SEWAGE DISPOSAL SYSTEM

MARYLAND STATE DEPARTMENT OF HEALTH

HOWARD COUNTY

SPECIFICATIONS - 2 bedrooms

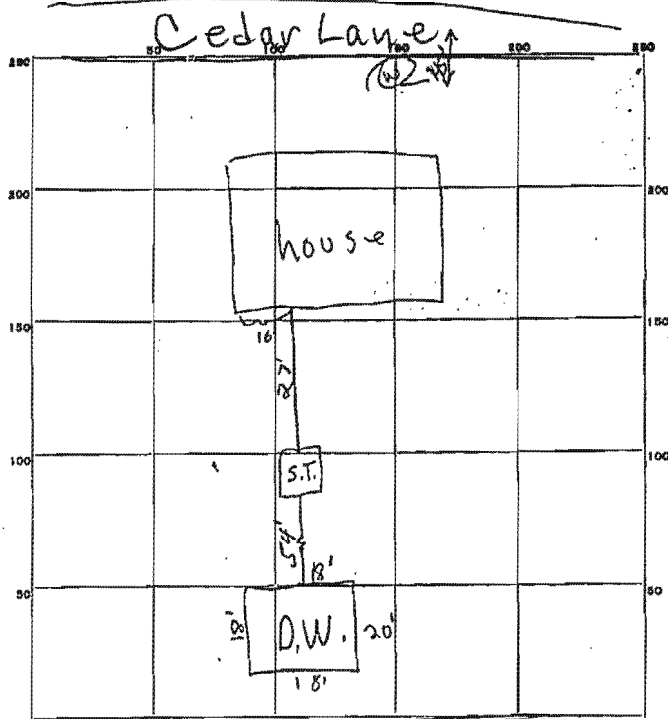
Dry well - 16 ft. sq. set 24" top for 12 ft. diam.
fill in rest with gravel.
Dry well must have 5 ft. depth of effective area
below the inlet pipe. WDM - 11/8/73

REMARKS 1/23/74 - Pot hole - partially blocked. called Mr. Evans to have system dug out and in to call
before any stone is installed
4/3/74 OK to put gravel around D.W. Revised
